UNITED STATES  
NUCLEAR REGULATORY COMMISSION  
WASHINGTON, D.C. 20555-0001

## SAFETY EVALUATION REPORT

Docket No. 71-9342  
Model No. Versa-Pac  
Certificate of Compliance No. 71-9342  
Revision 13

**Figure 1: Versa-Pac Component (SAR Figure 1-1)**

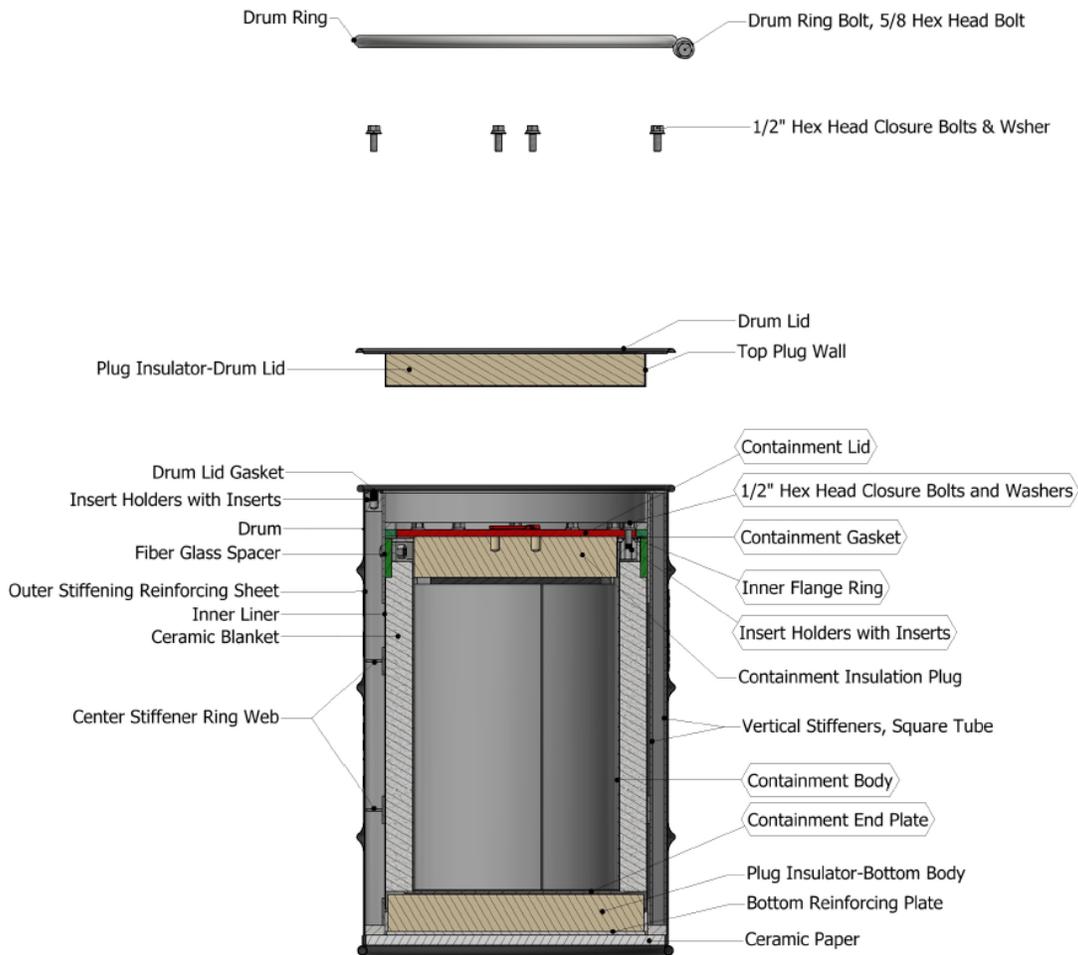
For the two Versa-Pac Type A(F) models, the VP-55 and the VP-110, the containment boundary is unchanged and is defined as the inner containment body with its associated welds, the containment end plate, the 1/2-inch thick containment closure plate, the inner flange ring, the silicone-coated fiberglass gasket, the 1/2-inch blind flange, the insert holders with inserts, and the 1/2-inch bolts. These components are illustrated in SAR Figure 1-1, "Versa-Pac Component Illustration," of the application.
